LAKE TAHOE COMMUNITY COLLEGE
Student Housing Building Project
RFP #22-23-002
Addendum #1

PROJECT: RFP #22-23-002 – Student Housing Building Project

DATE: June 22, 2023

Description(s): Revised Increment 1 Drawings to show:

A5.9.1-2

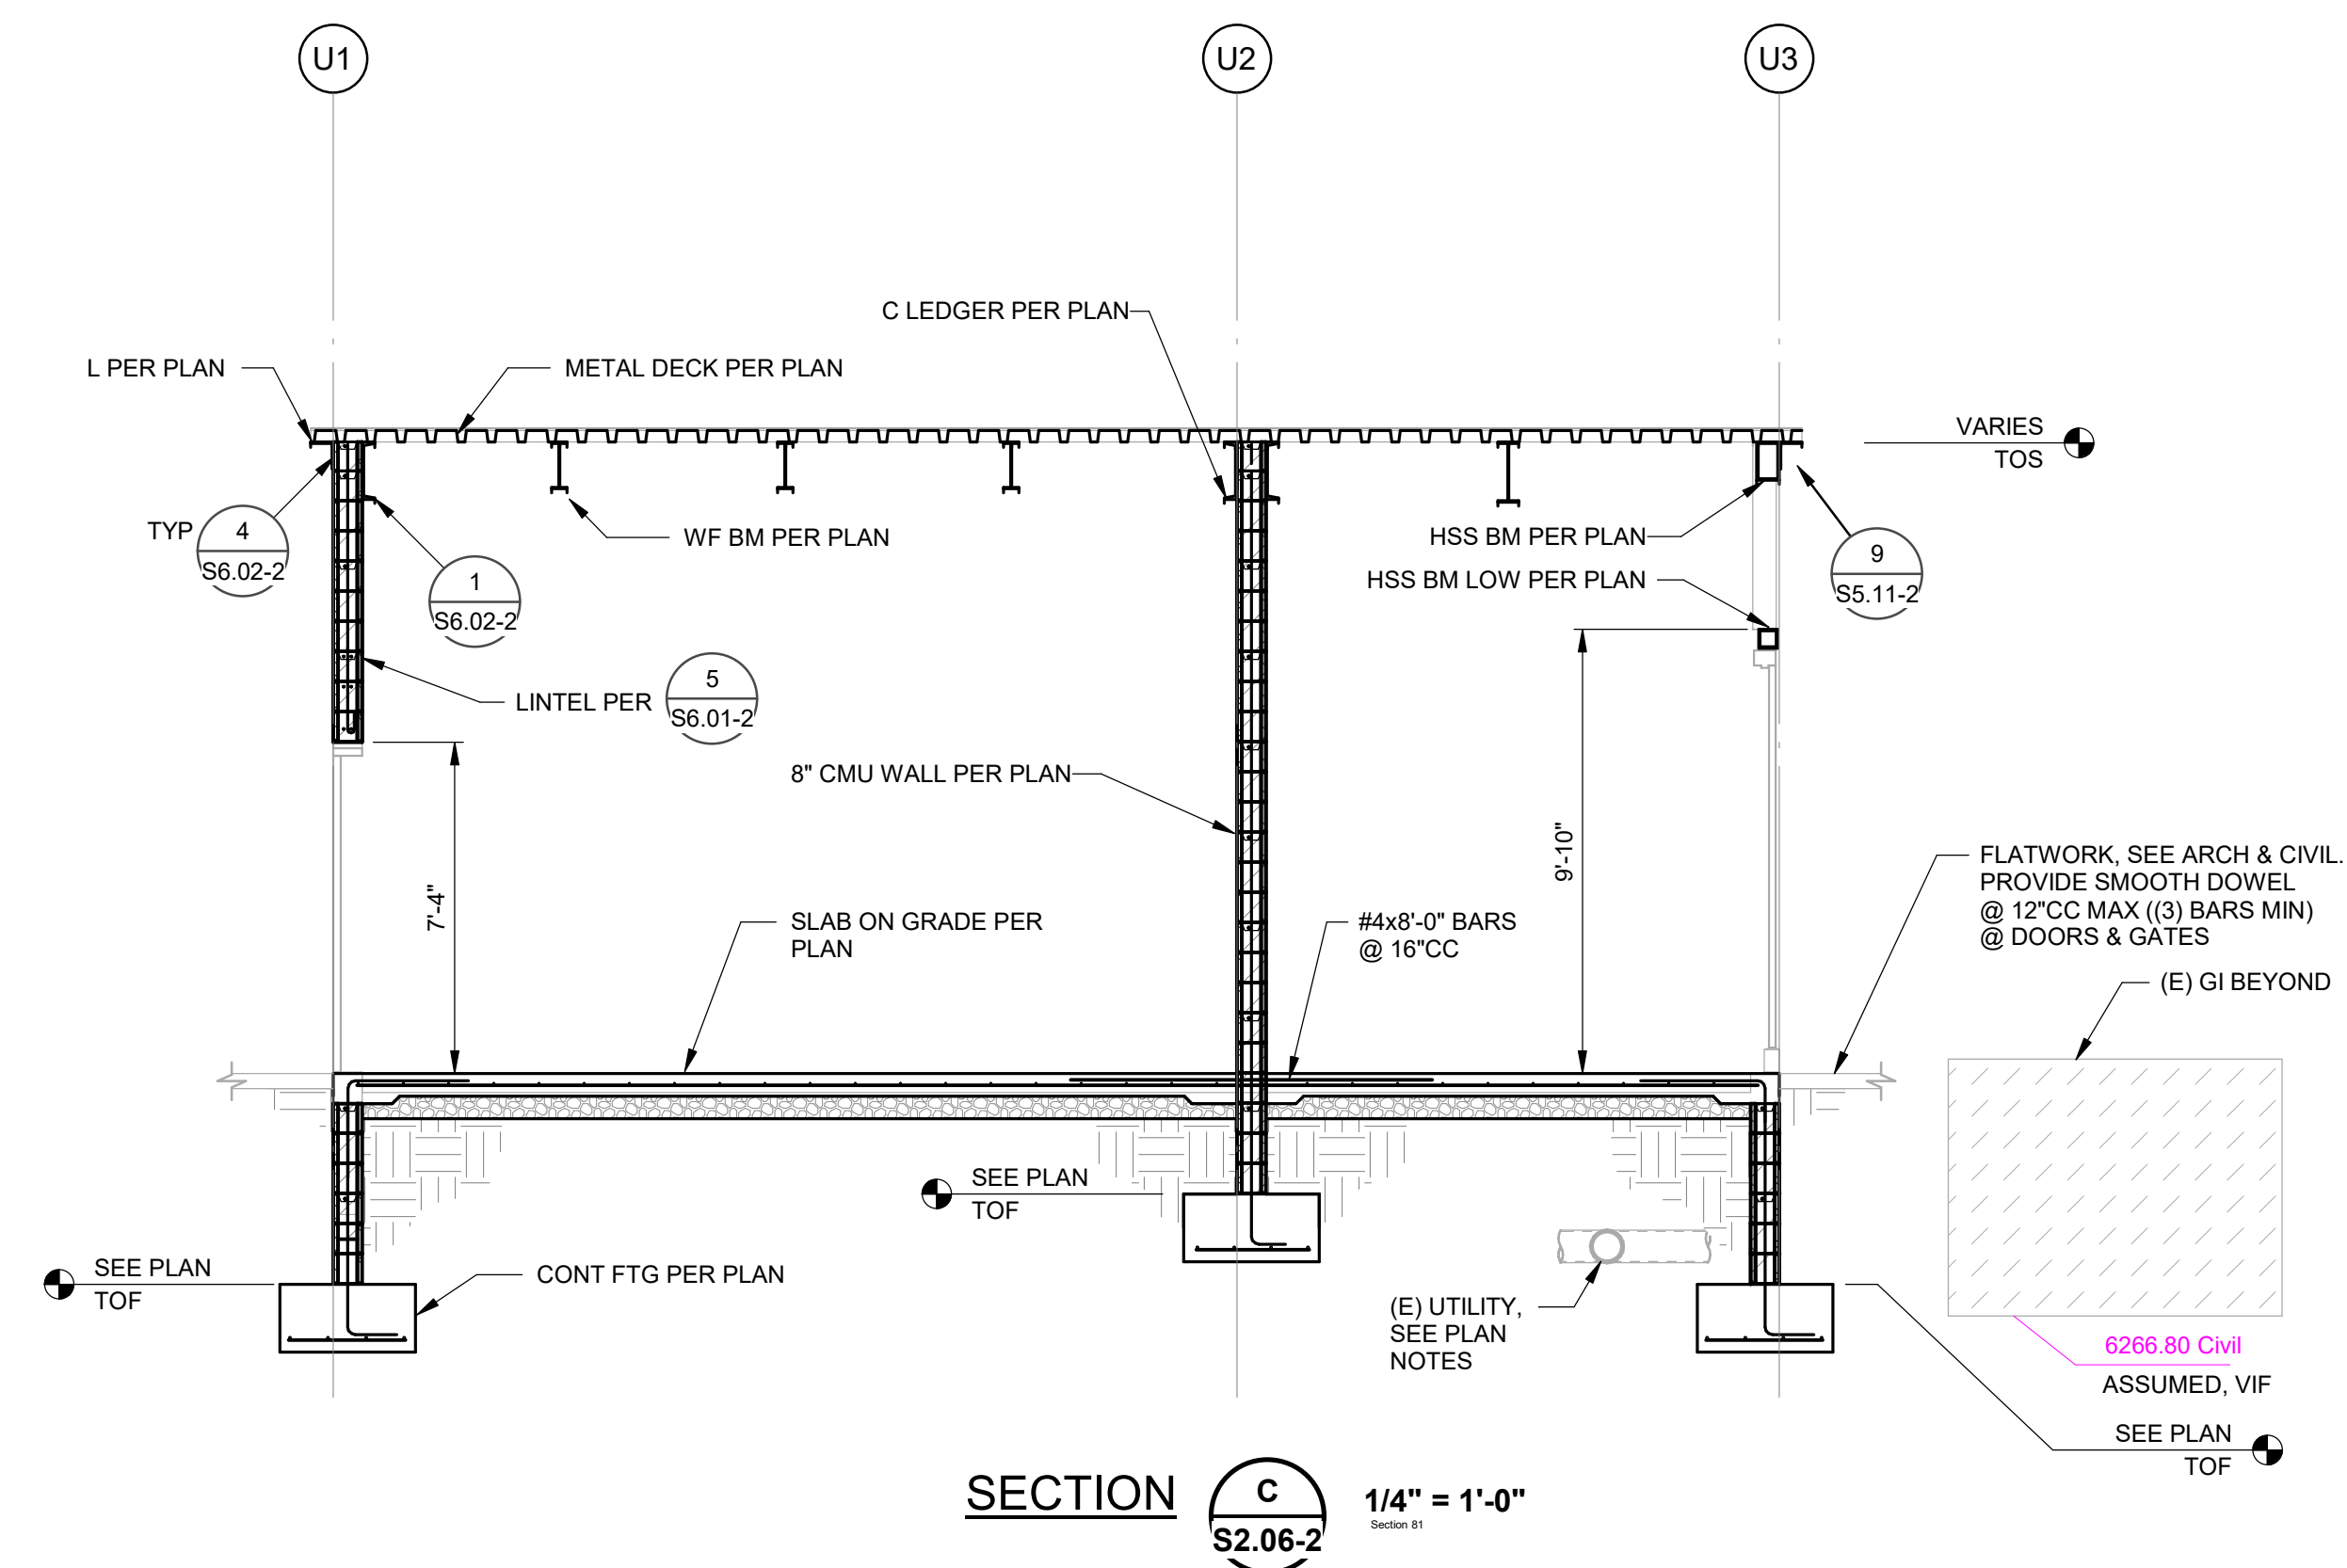
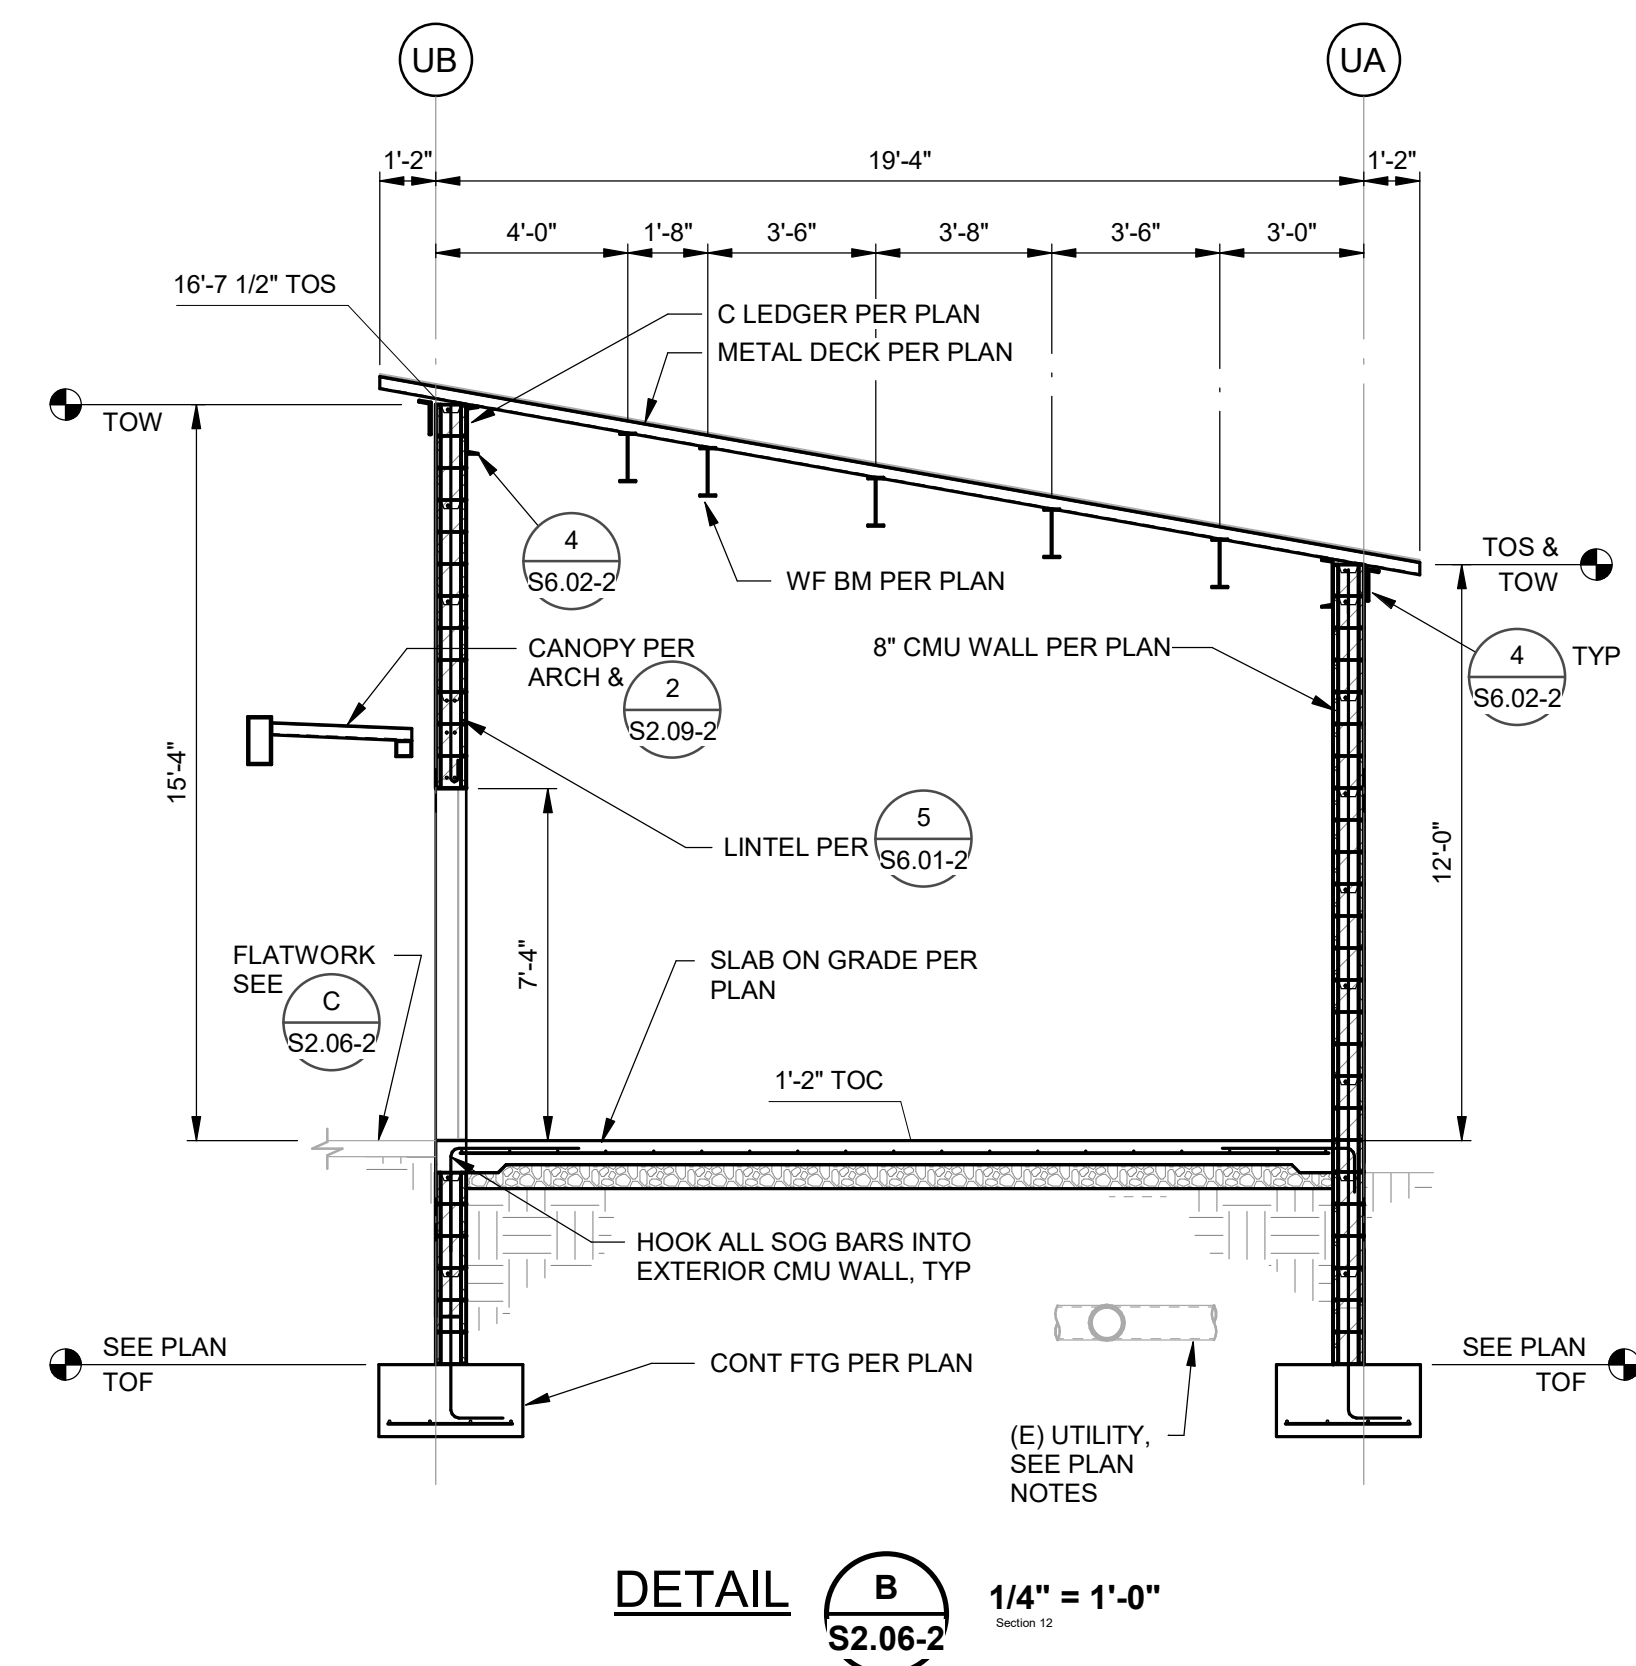
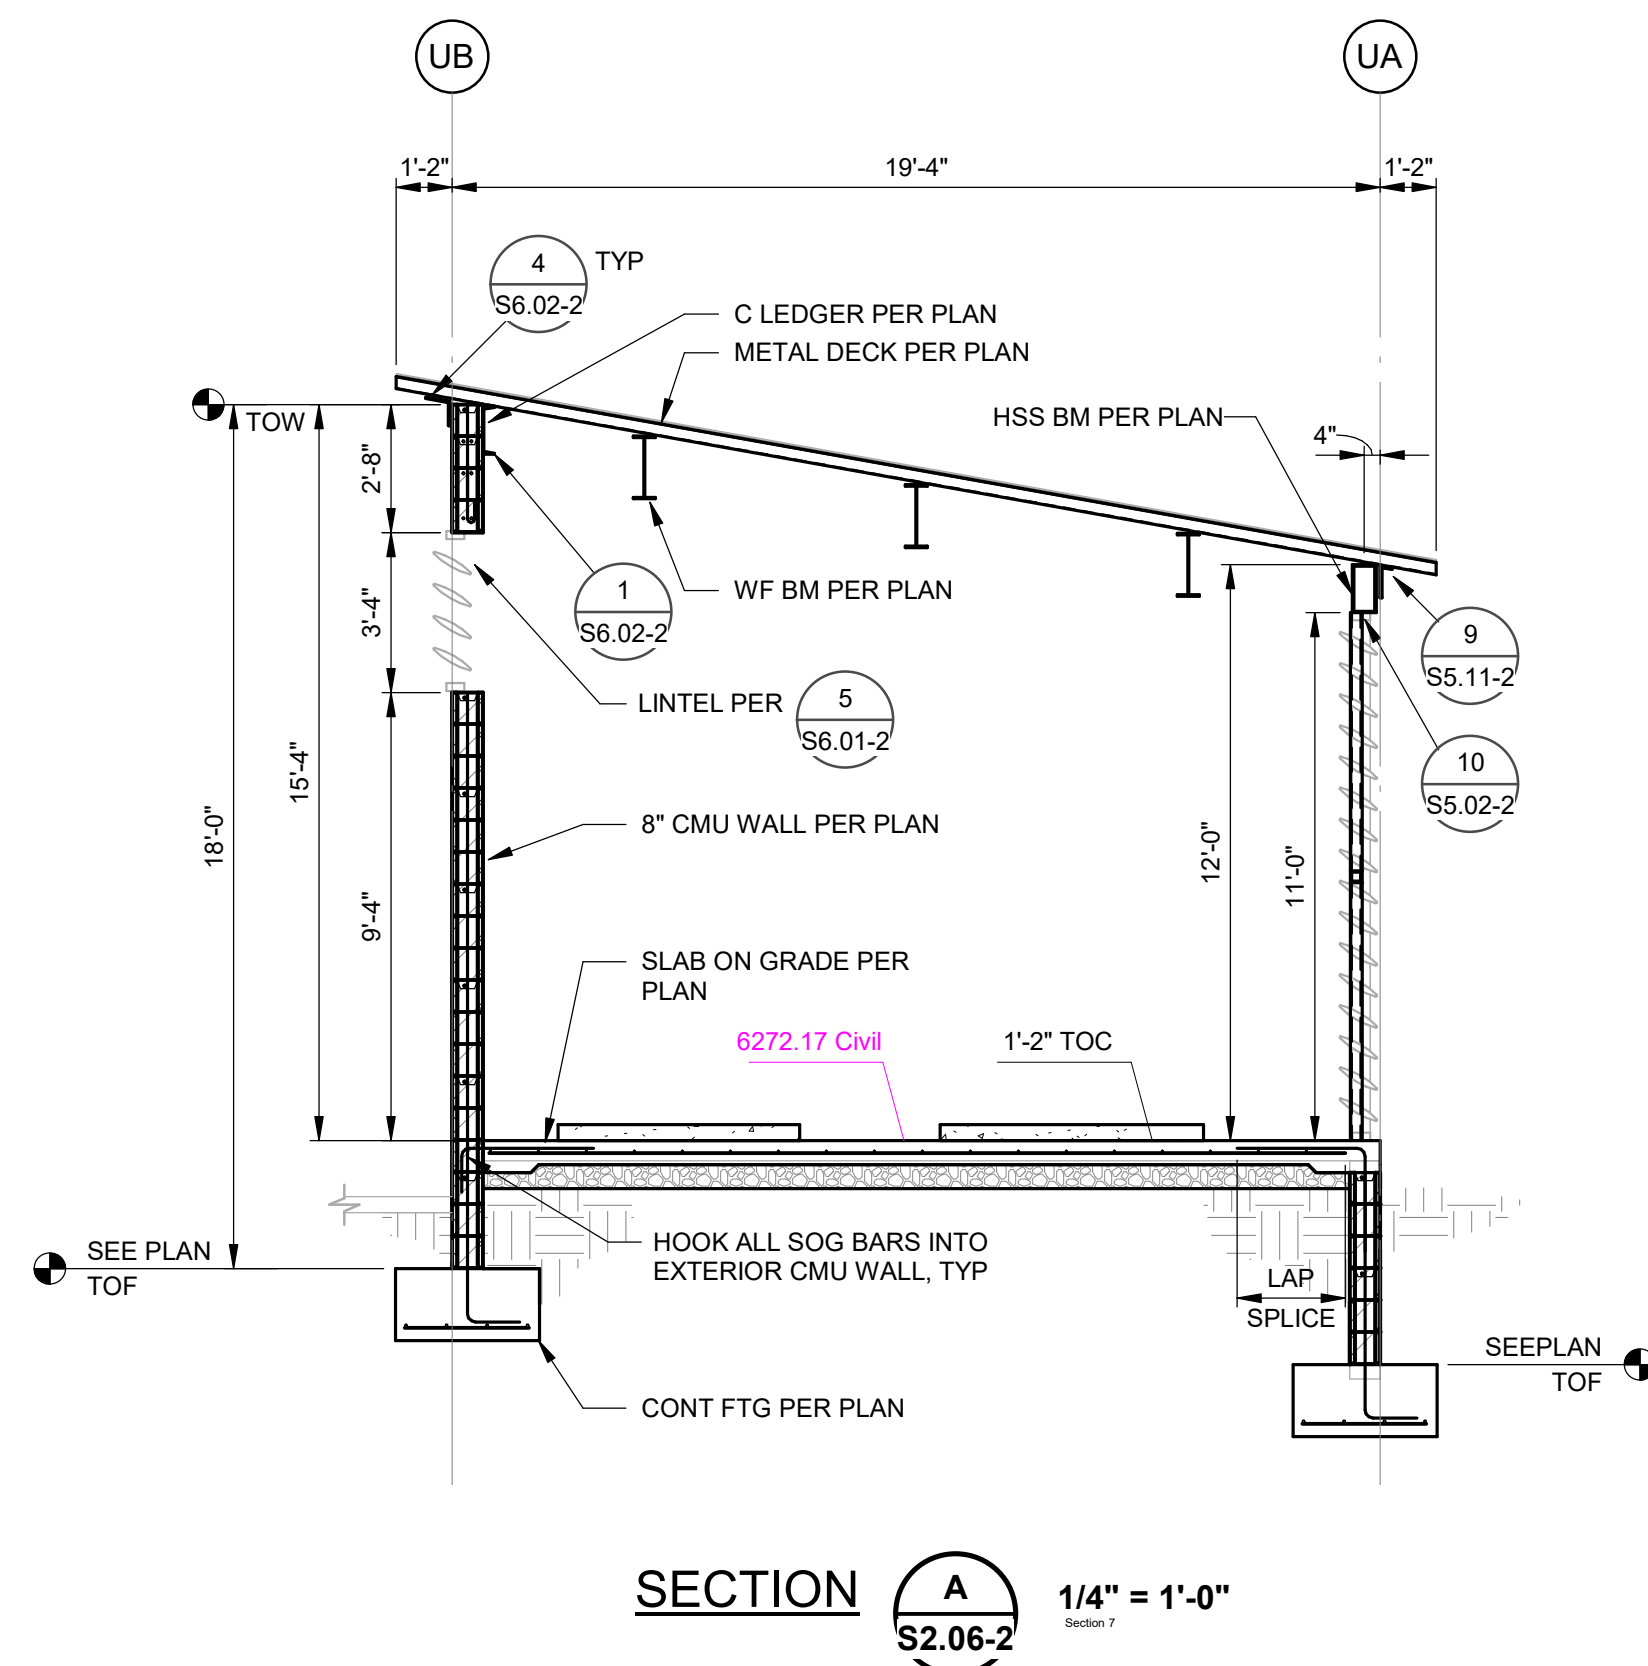
- Sheet 1/A5.9.1-2, strike note "concrete curb" from room E-1.
- The line work illustrated is the continuous trash enclosure bin guard illustrated in typical detail 5/A5.9.2-2.
